- Board of Directors
Engineering and Operations Committee

Appropriate \$430,000; authorize two rehabilitation projects at the F. E. Weymouth Water Treatment Plant; and adopt an addendum to an environmental impact report for the Weymouth plant (Approp. 15477)

**ADDENDUM NO. 9 TO THE
FINAL F.E. WEYMOUTH FILTRATION PLANT
OZONATION FACILITIES AND SITE IMPROVEMENTS PROGRAM
ENVIRONMENTAL IMPACT REPORT**

Figure 2
Proposed Modifications

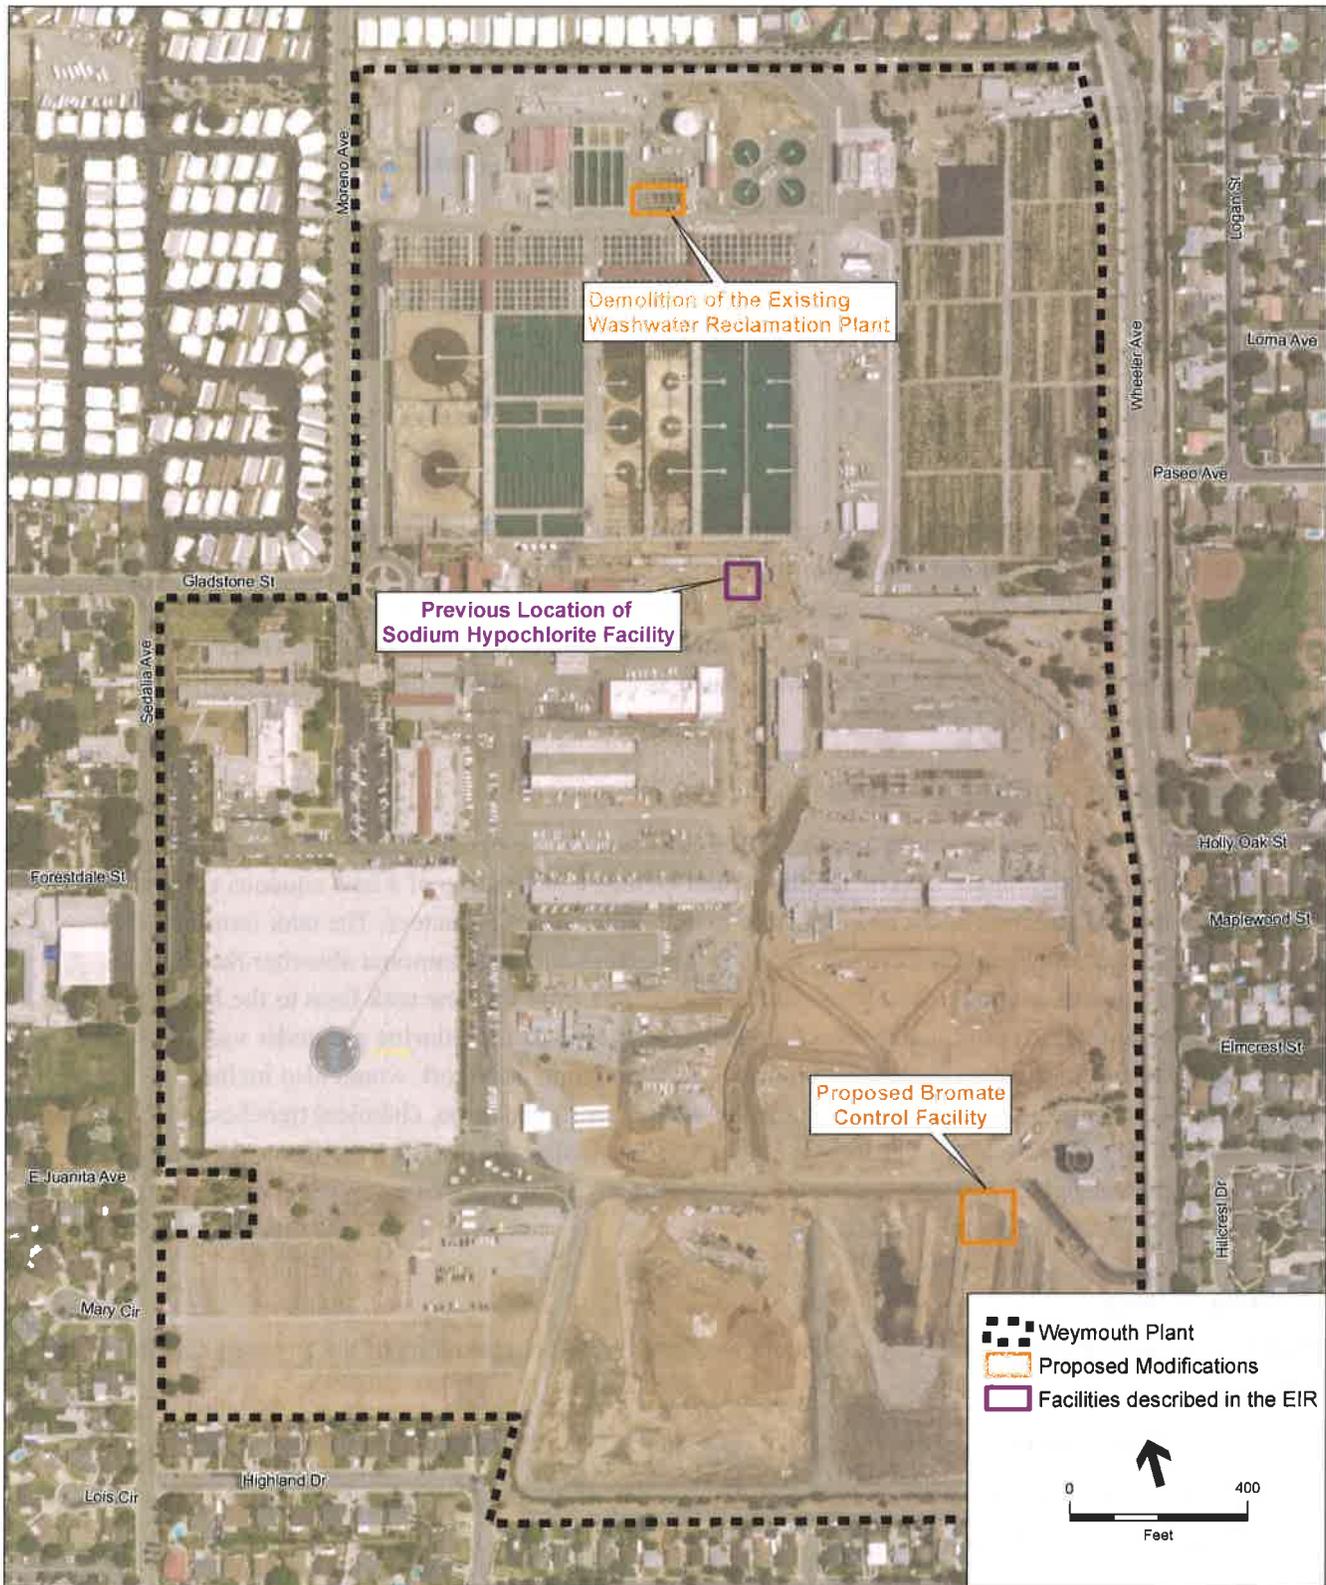
The proposed modifications consist of the demolition and removal of the WWRP No. 1 Facility, the relocation of the Sodium Hypochlorite Facility to the WWRP No. 1 Facility site, and construction and operation of the Bromate Control Facility (**Figure 2**).

The facility was originally planned to be located in the north-central portion of the plant site south of the Mixing and Settling Basins and east of the Mechanical Maintenance Shop (see Figure 2). However, as previously mentioned, during final design of the Sodium Hypochlorite Facility, Metropolitan determined that the best location for future operations of the facility would be at the WWRP No. 1 Facility site (see Figure 2), which is currently out of service. The Sodium Hypochlorite Facility would be relocated just north of Filter Building No. 2 approximately 850 feet north of the original location identified in the EIR. The new location is approximately 330 feet from sensitive receptors (mobile home park) who are located along the north perimeter of the plant. The site preparation for the relocation would involve the demolition and removal of the existing WWRP No.1 Facility. The WWRP No. 1 facility is 23-feet deep and houses piping and mechanical equipment. The excavation for this project would include the upper 5 feet. The remaining 18 feet will be filled. The original excavation impacts associated with the Sodium Hypochlorite Facility were fully analyzed in the EIR. This addendum evaluates excavation impacts as they relate to the demolition of the WWRP No.1 site and the sensitive receptors along the northern perimeter of the plant. Air quality and noise impacts to sensitive receptors will be analyzed as a result of the excavation activities. Due to excavation related to the demolition of the WWRP No.1 Facility, impacts to cultural resources will also be analyzed.

The Bromate Control Facility would be constructed just south of the ozone generators in the southeast portion of the plant (see Figure 2). The facility would include construction of a new aqueous ammonia tank farm with roof structure and a new structure to house the chlorine ejectors. The tank farm includes unloading facilities, chemical feed system, secondary containment, and ammonia absorber facilities. In addition, two aqueous ammonia feed lines would be extended from the new tank farm to the injection point at the plant inlet. Approximately two four-inch-diameter lines for chlorine gas under vacuum would be added from the chlorinators to the new chlorine injection point. The work would also include modifications to the plant's utility piping, control systems, instrumentation, chemical trenches, and chemical leak detection systems. The total footprint of construction for the Bromate Control Facility would be approximately 3,200 square feet (50 feet by 52 feet); total depth of excavation would be approximately 12 feet below the surface.
